Section 8.00 & 9.00 comprises point-by-point responses to both the Pre-Application Advice provided by MSDC dated 17th November’23 ref: DM/23/1480 and advice provided by Place Services dated 12th November ’25 ref. DM/25/0133. In addition, responses to the Conservation Officer comments raised on 5th June 2026 are also included in this section.

SECTION 8.00-9.00 Planning Pre-App’s DM/23/1480 & DM/25/0133

Responses to and Comparables with Current Full Planning/Listed Building Consent Applications
(including response to Conservation Officer Comments 05.06.26)

8.01 Proposed Ground Floor Extension (A1) & Library Windows (A2)

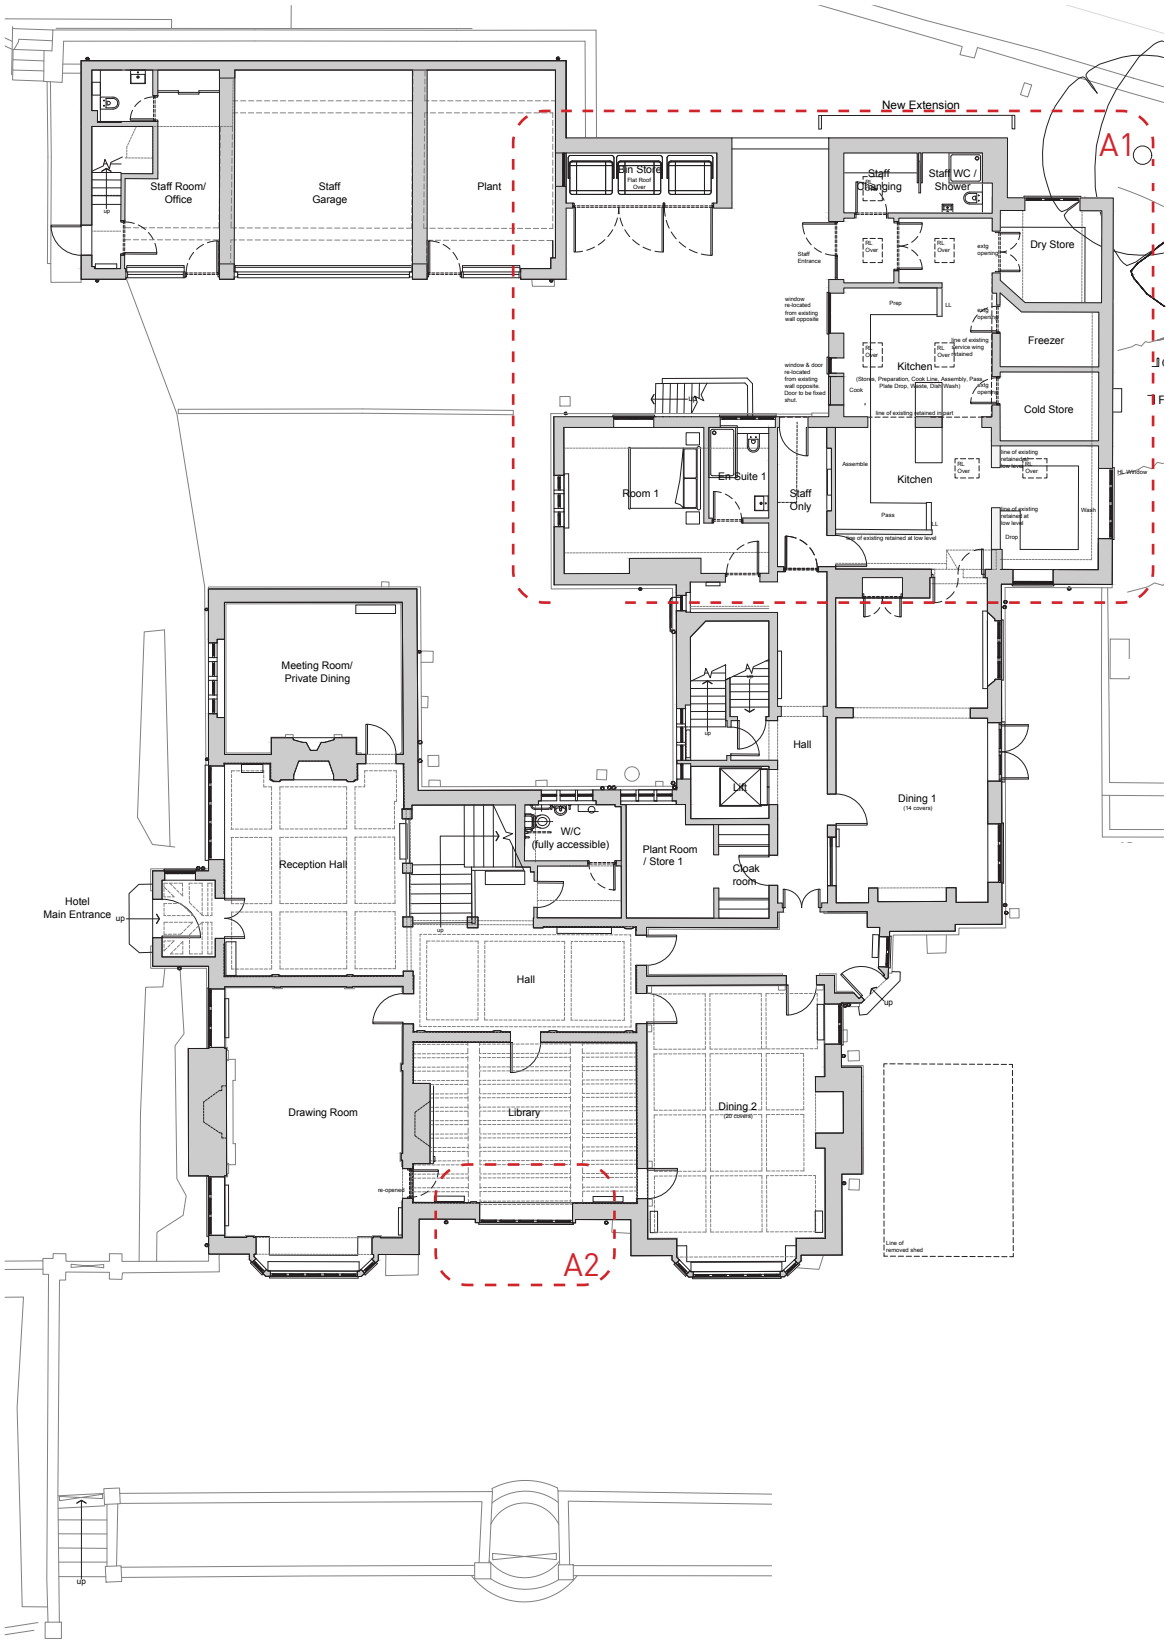
A1
“The proposed extension to the ground floor of the building is within the courtyard area to the north east of the building. This area is flanked to south and east by what appears to be the original service area/wing of the house, which while not as architecturally grand or imposing as the main part of the building containing the family rooms, is nonetheless of character and interest retaining original features such as leaded windows and doors onto the courtyard. The yard itself, with its herringbone brick pavers, is also an attractive feature of the setting of the house. Although towards the rear of the building, the yard area is visible in closer views from the main entrance drive to the house, and forms part of the context within which the main entrance façade is appreciated as one approaches the house along this drive. For these reasons I would question whether this is an appropriate position for an extension.

In my opinion, a kitchen extension might be better positioned to the opposite side of the existing service wing (currently containing a gym), which although it would be visible from the terrace to the south east of the house, could if appropriately set back in relation to the main building (as the existing wing is), be appropriately subservient in views of the house from the terrace and gardens, and would allow the character of the courtyard facing elevation, which is in fact probably the more significant in terms of the context in which the house is appreciated, to remain largely intact, as well as the courtyard itself. In conjunction with this I would not object to a more modest extension to the northern end of the existing kitchen wing linking across to the modern garage building, providing this preserved the key features of the wing, and the character of the courtyard space.”

A2
“During our site visit we noted that the existing windows to the library are original, and the original fabric beneath them both internally (wood panelling, part of the designed decoration of the room) and externally (a stone plinth). The existing window is also part of the designed composition of the elevation. For these reasons I consider that the proposal to remove the fabric below the window sill, and replace the existing windows with French doors, is contentious, and will detract from the special interest of the listed building. This aspect of the proposal should be omitted from the formal scheme.”

Further comments received on 05.06.26 from MSDC Conservation Officer (CO) regarding ‘greater loss of historic plan form and fabric’ have been considered and addressed as follows -
Whilst we acknowledge the comments of the CO, the design team believe this modest extension to the rear of the house (significantly reduced from the pre-app. stage) is in the most appropriate location for numerous reasons as stated previously on this page. One of the key factors is the positioning of this extension, housing kitchen and other back of house ancillary facilities, within the area referred to by the CO as the service wing of the listed building -in essence, the only logical position for this, at the rear of the building and away from both primary spaces and the much grander elevations / rooms of Chownes Mead.

A1
Whilst the comments of the LPA re. the pre-app proposal for the repositioning of the extension to the East of the listed building (in close proximity to the new spa and pool building) are acknowledged, there is a clear rationale for the positioning of the new extension to rear (North East) of the main building as cited opposite.
However, mindful of the comments made, the overall size of the proposal has been reduced by c25Msq (c. 40%) in order to limit any perceived impact on the listed building.

1. Reduction overall by c.3000mm in width and c.8300mm in length (c.25m²)
This in turn enables retention of the internal central corridor running north-east to south-west. This will be used for staff access at the rear allowing direct connection with the service areas to the north-west of the hotel.
The retention of much of the original service yard area also includes the external access stairway to the basement level as well as the north-east window to room 1, which will be obscured glass.
2. The roof over the new extension will mirror the existing service wing roof with a Sussex hipped end and ridge height to match. A small central stepped lead valley will be positioned between the two.
3. The bin storage is reduced in size and detached from the new extension.

A2
The comments of the LPA re. the pre-app proposal to remove the bay window and fabric below the window sill and replace with French doors are acknowledged and have been omitted from the current scheme. This area will therefore remain as existing.

8.02 Proposed First Floor Bedroom 4 & 5 (B1)

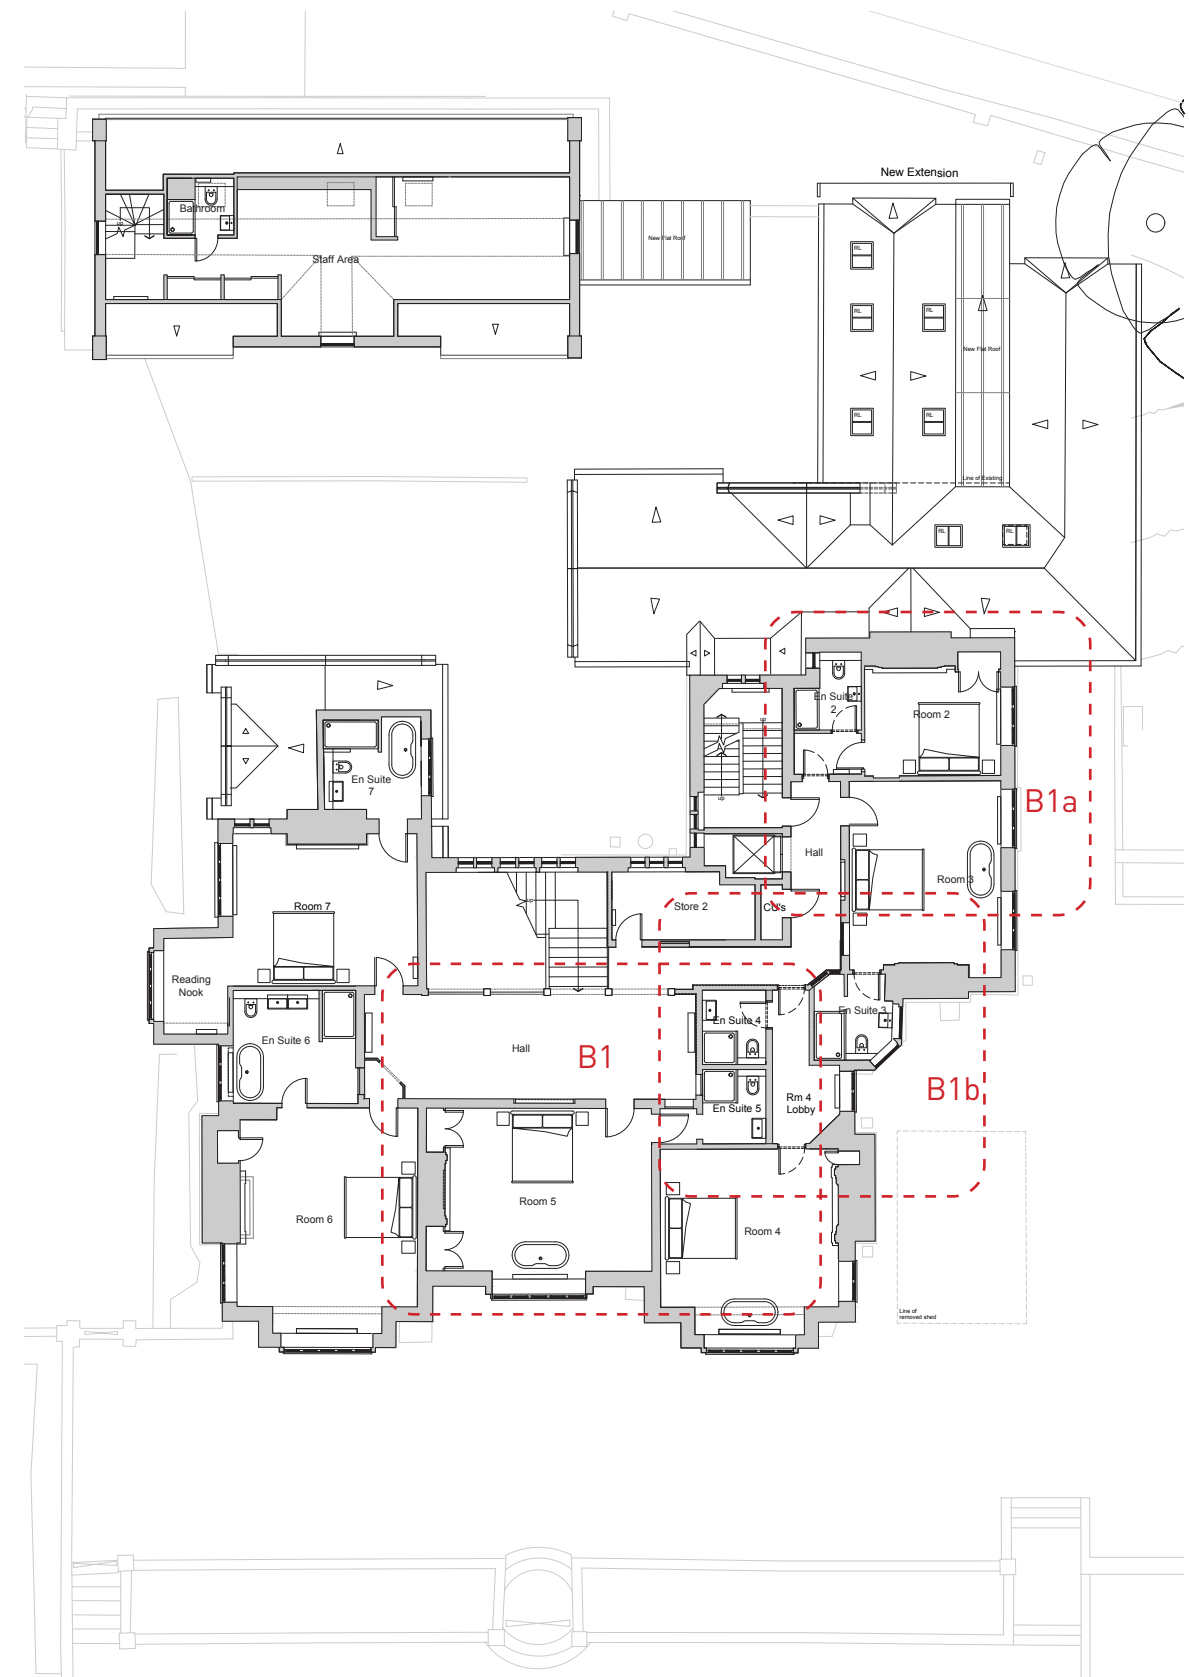
B1
"At first floor, the alterations to the existing floor plan are in general relatively minor in their impact, and are not considered contentious subject to detail in light of the existing permission. This is with the exception of the proposed works to bedroom 5, which involve bisecting the room by the insertion of an ensuite. This room is one of the principle family bedrooms, and the adverse impact on its original proportions which would result from the proposed work would in my opinion unacceptably impact on its character. This aspect of the proposal should be reconsidered- potentially the room, which is already linked with the adjacent master bedroom, could be incorporated into a suite with that room?"

B1
The comments of the LPA re. the pre-app proposal to insert an en-suite shower room into principal room 5 and bisect the space have been addressed with re-design to suit.

The current proposal maintains room 5 as existing, retaining its original features, cornicing, skirtings etc insitu including its entrance door from the landing (previously repositioned). The adjacent dressing room and ensuite to existing bedroom 4 is adapted to form a lobby, accessed from a new entrance door within the panelling of the hallway to match all other doorways on the landing area by replicating panelling, architrave, over door frieze and door / ironmongery to match existing complete. The new en suite is positioned off of the lobby (in the position of the existing en suite), modified to suit new layout to bedroom 4. The remaining part of the original dressing room is proposed as bedroom 5's ensuite.

B1a - Room 2 and Room 3 have both been re-worked to align with the extant permission by re-opening the doorway from the hall and closing (locked shut) the interconnecting door to Room 3. The ensuite has been re-positioned to the corner of the room with shower, wc and whb. Room 3 is maintained as the original layout with door formed through to ensuite (existing shower room).

B1b - With regard the existing dressing room, a comprehensive study has been carried out and is referenced on pages 67-73 of the DAS.

8.03 Proposed Reading Nook (C1) & Second Floor Bedroom 13 (C2)

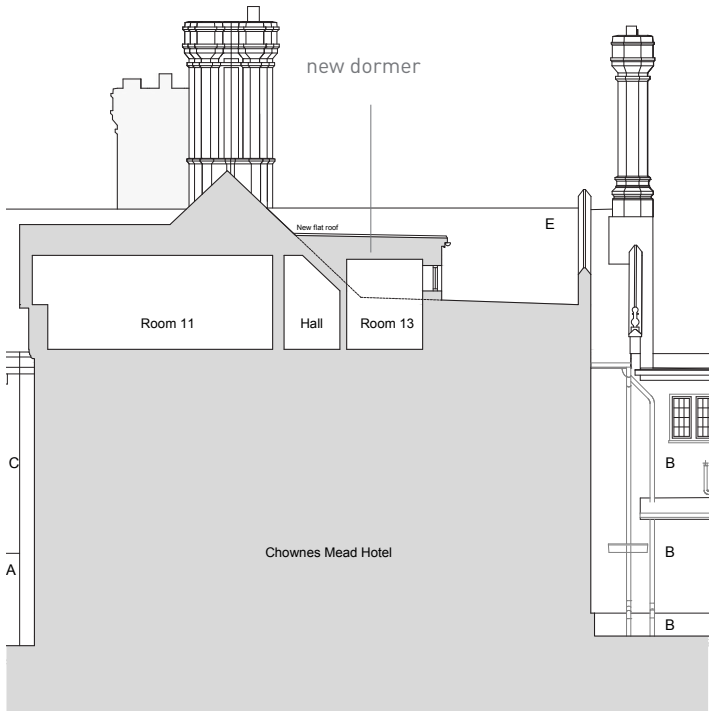
C1
“The proposal also shows the removal of wall enclosing the proposed ‘reading nook’- this would result in an unacceptable loss of historic plan form and fabric and I would suggest should be omitted from the scheme.”

C2
“At second floor, the majority of works relate to the insertion of ensuites to the existing attic bedrooms. Although this will have some impact on their proportions, given the secondary importance of these spaces this aspect of the proposal is on balance considered acceptable. It is also proposed to alter the roof form above the existing kitchen and adjacent bathroom/ walk through cupboard space to create an area of flat roof which allows the formation of a link between the spaces, to provide an additional ensuite bathroom. Further detail including proposed sections, elevations and a roof plan would be needed for fully informed comment, however in principle this may be acceptable, provided that there is no adverse impact on the external appearance of the building, and that as discussed on site, the internal character of the adjacent corridor, with the angled intrusions revealing the shape of the original roof above, is preserved. The level of interest of the joinery within the walk through cupboard space should also be considered- it is proposed to partially remove this, which is work which should be assessed in an accompanying heritage statement, and if necessary amendments- such as the reuse of the joinery in question elsewhere in that room - considered.”

C2a - The layout has been amended to incorporate as much of the existing layout as possible to avoid losing fabric.

C1
The comments of the LPA re. the pre-app proposal to remove part of the wall enclosing the proposed reading nook are acknowledged and thus this area will remain as existing.

C2
The comments of the LPA re. the pre-app proposal for the removal of part wall (including cupboards) to form a link between kitchen and bathroom are acknowledged. Proposed sections and elevations are included within the planning application package which shows no adverse impact on the listed building. The new link will have a traditional lead rolled flat roof over and this will be considerably withdrawn towards the rear of the section of roof set back behind the primary rear double gables. The new roof will not be visible from courtyard area at the rear.
The existing joinery is not believed to be of significant heritage value, and it is not proposed to reuse these within the new proposals in a specific location. However they may be re-purposed in storage areas if appropriate.
